Re: Second Submission Review: The Aurora Highlands Subdivision Filing No 31 - Plat
Application Number: DA-2062-60
Case Numbers: 2024-3022-00

Second Submission Review

Re: The Aurora Highlands Subdivision Filing No. 31, Case # DA-2062-60

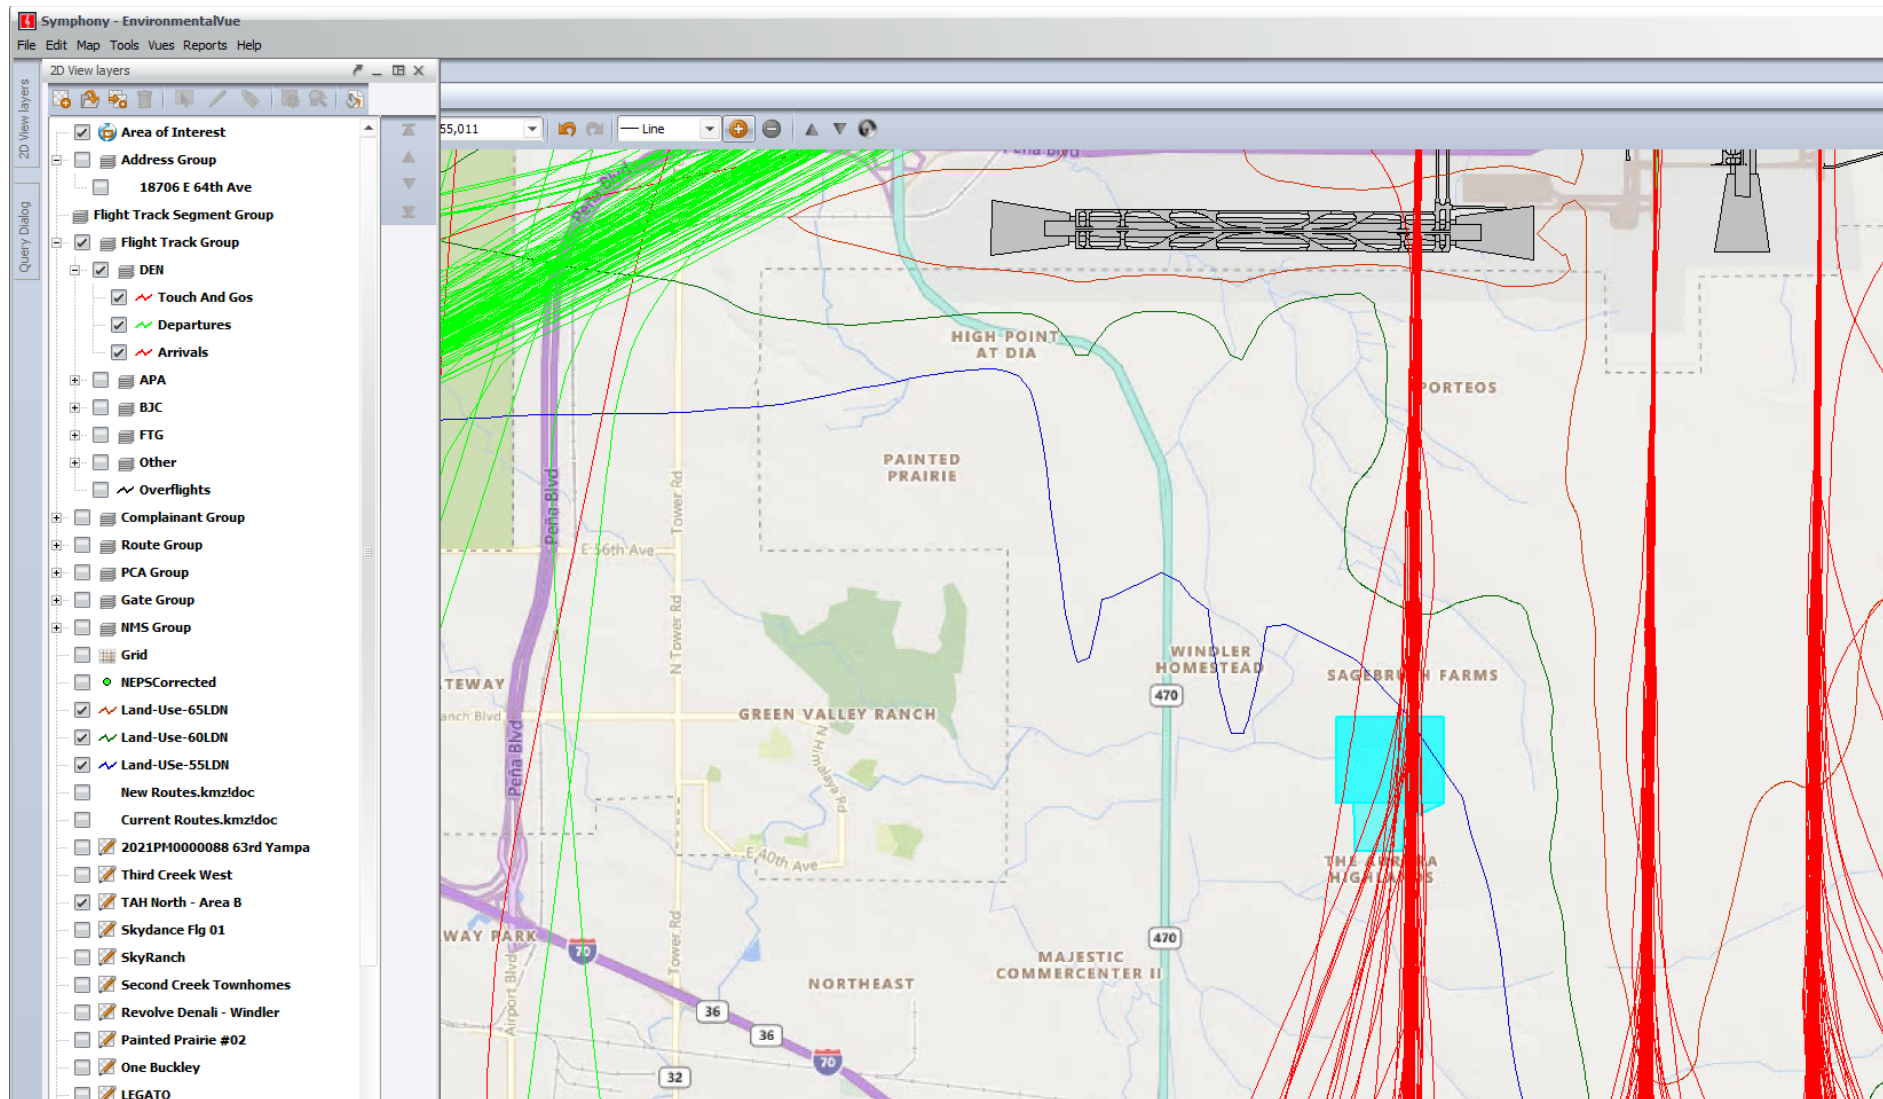
Other areas in this development have been reviewed previously, and the noise analysis still holds true. This portion of the development, depicted in light blue on this map, will have arrival overflights from the south at altitudes of between 1,300 feet above ground level (AGL) and 1,600 feet AGL depending on the aircraft type and what arrival runway the Federal Aviation Administration (FAA) air traffic controllers have directed the aircraft to land on. If the winds are out of the north aircraft will land coming in from the south on final approach to DEN. Aircraft currently arrive to DEN on runways 34L and 34R and with the potential of 4 North/South runways on the West side of the airfield there could be even more daily arrival overflights of this development. The future runways are depicted in black outline/grey fill on this map of flight data from 2/23/23. This day of flights depicts a typical flight pattern for a 24 period. **On this day there were 212 arrivals to runway 34R from the south.**

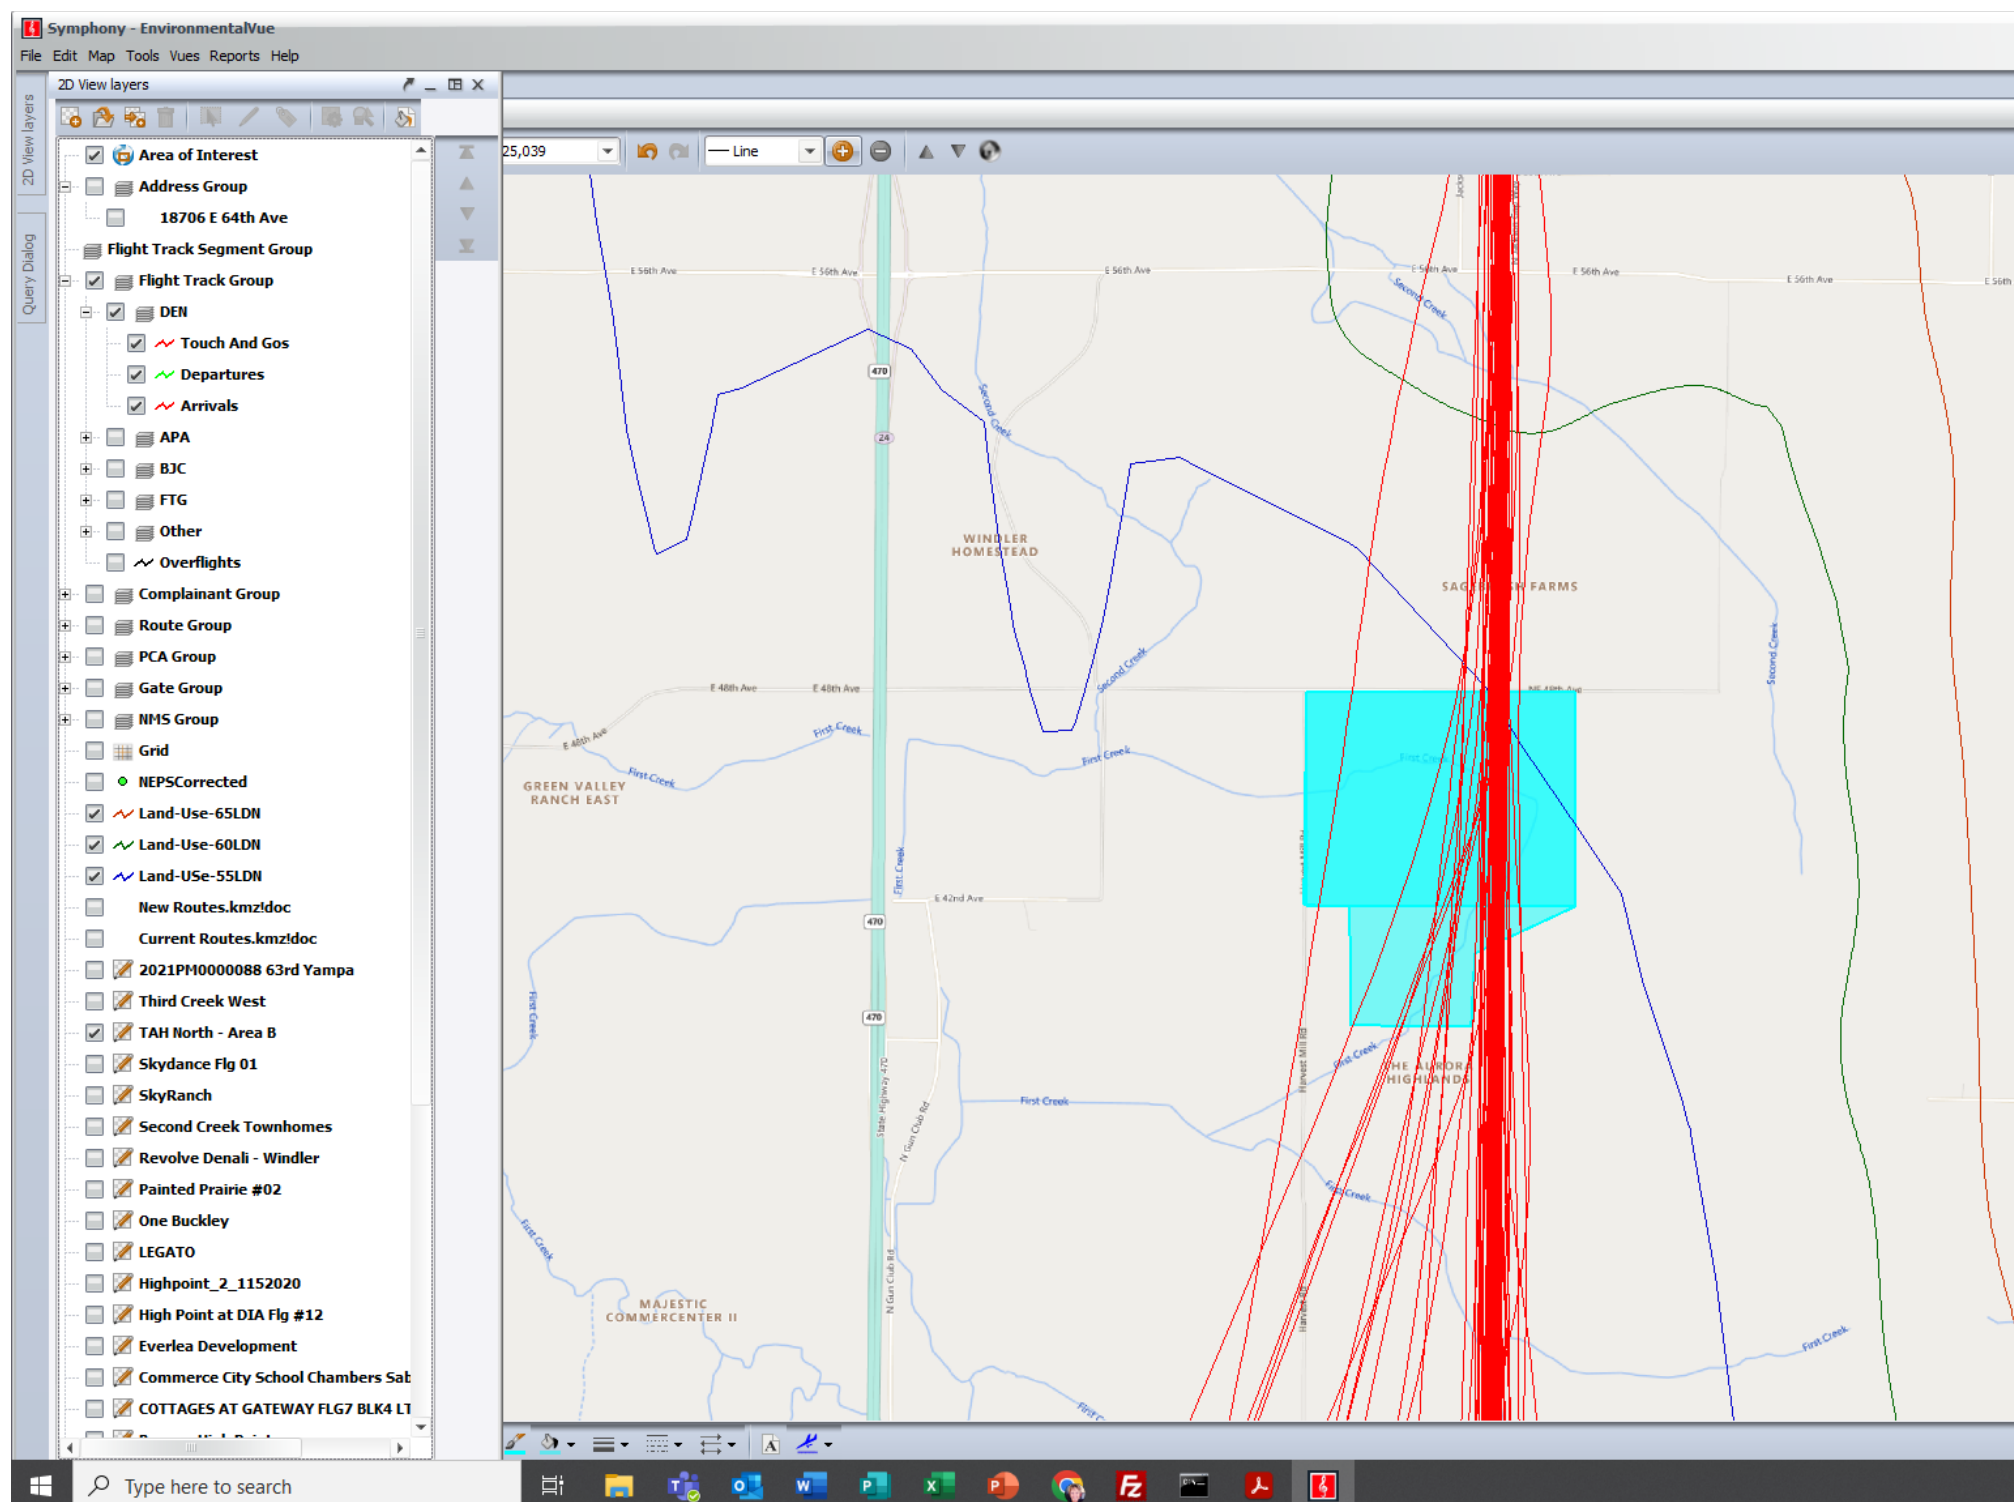
Same flight data from 2/23/23, zoomed in to see the 55, 60 and 65 DNL contour and the property area in light blue. The 55 DNL intersects the property on the northeast corner. This portion of the 55 DNL includes the arrival flight patterns to the additional 2 potential north/south runways on the west side of the airfield. There will be upwards of 200+ arrivals per day to 34R and at some point there could be arrivals also vectoring to the other 2 future runways on the west side of the airfield.

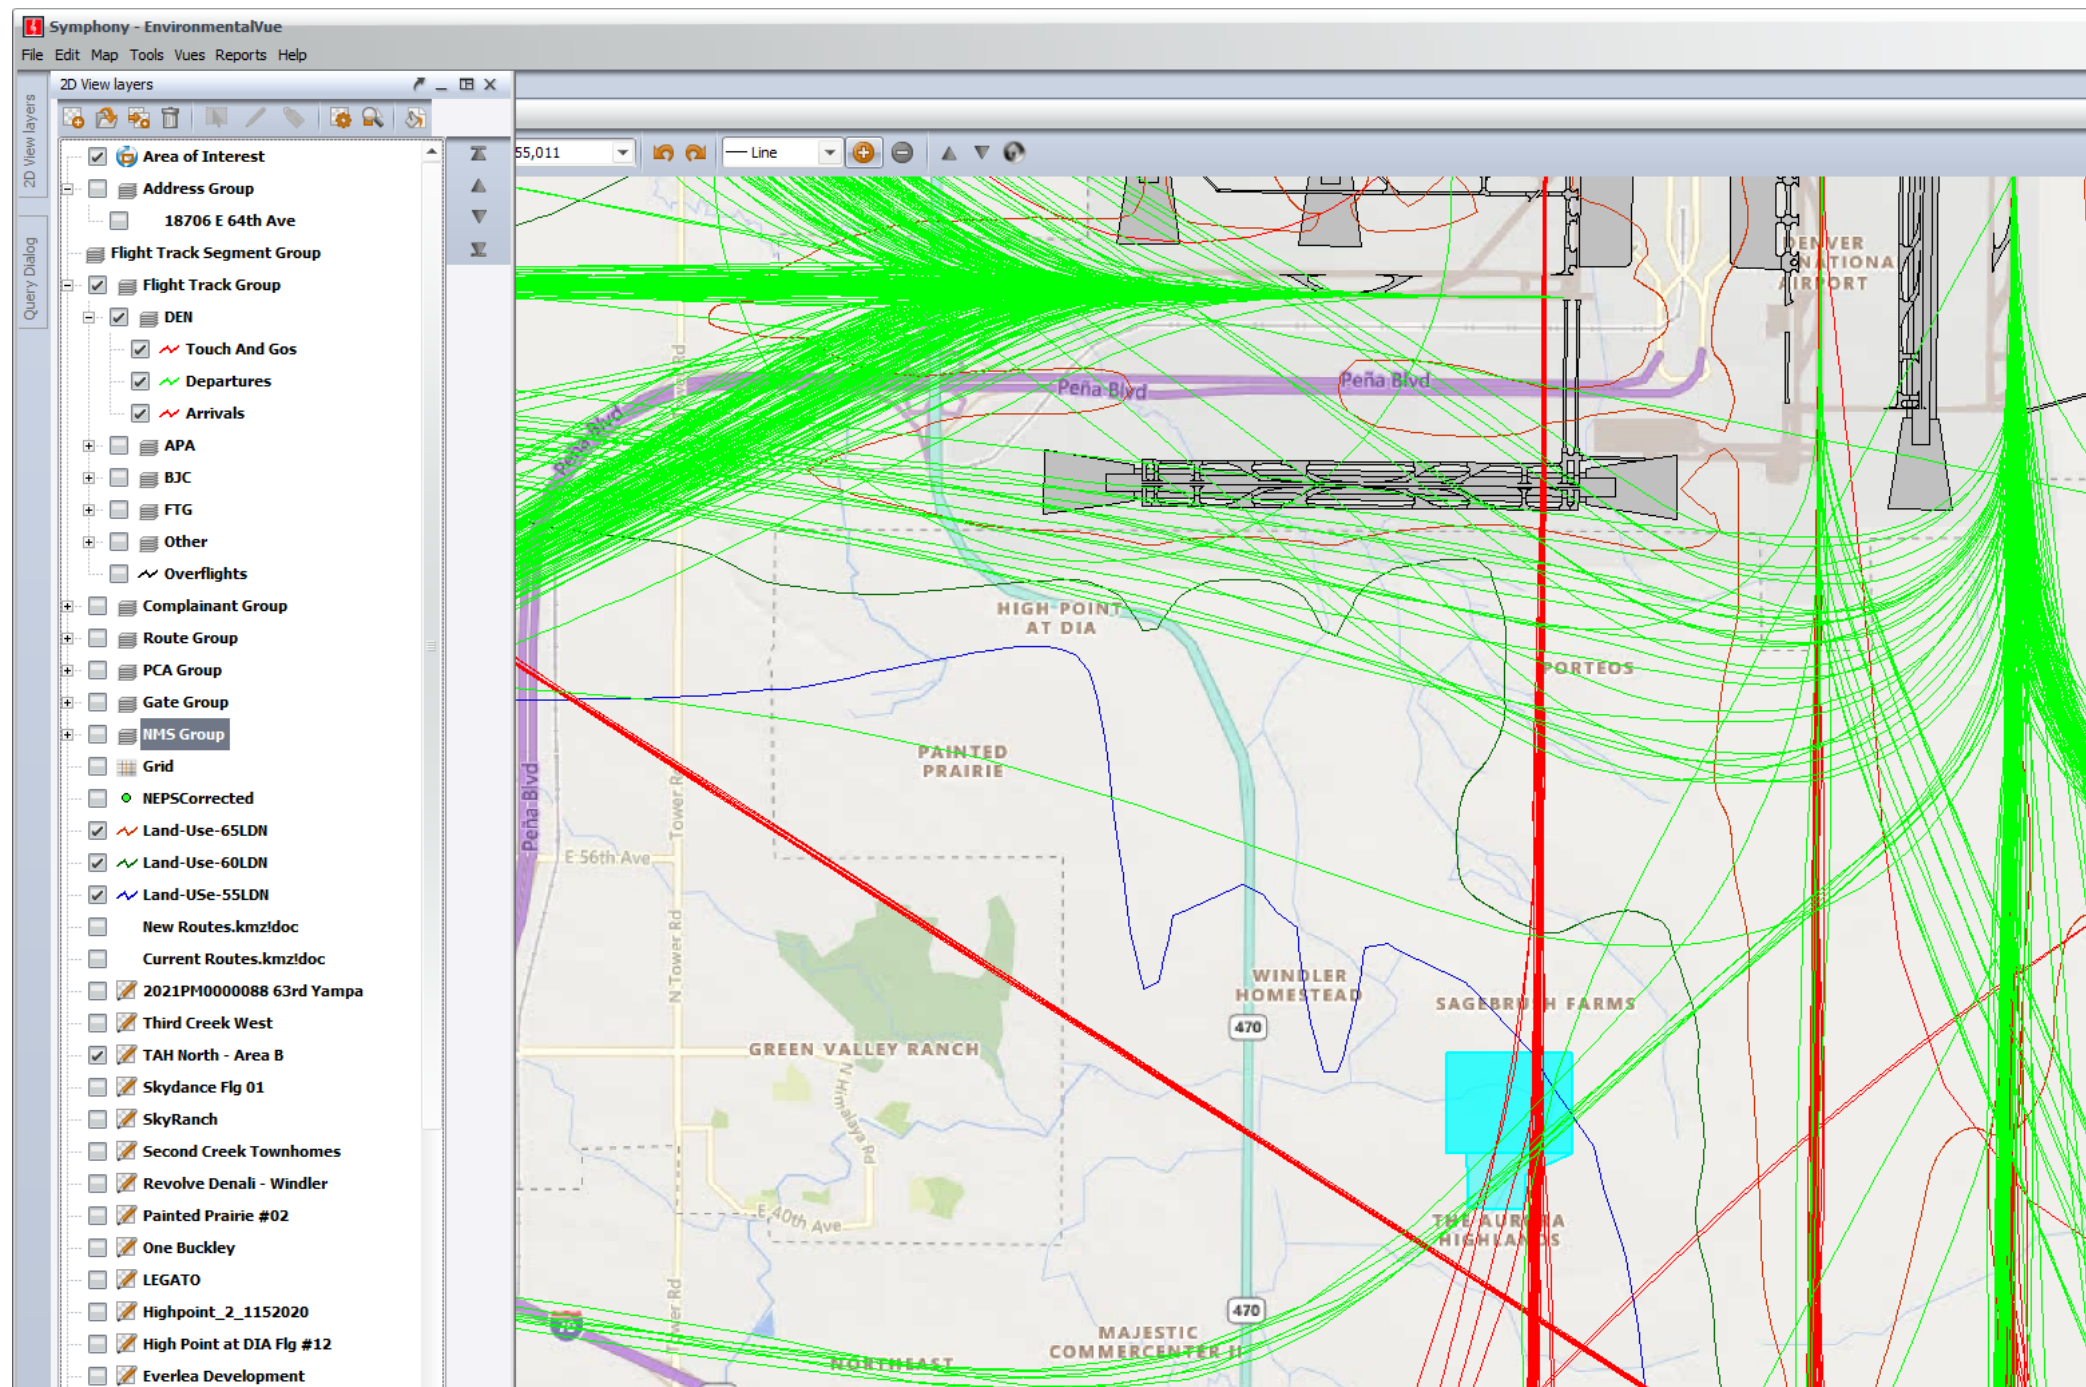
Flight data from 2/26/23. Few arrivals in line for final approach to 34R and there are also some departures that could fly near the subject property. On this day there were a few departures from runway 17L. They are cutting through the subject property. Their altitudes can vary based on aircraft type. On this day they were between 2,300 feet AGL and 4,200 feet AGL. These aircraft will be louder than arrivals as they are under full power departing DEN. During periods of high winds or inclement weather the FAA will depart aircraft to the south and then turn them west to get back onto the final pattern. This could happen from any one of the north south runways.
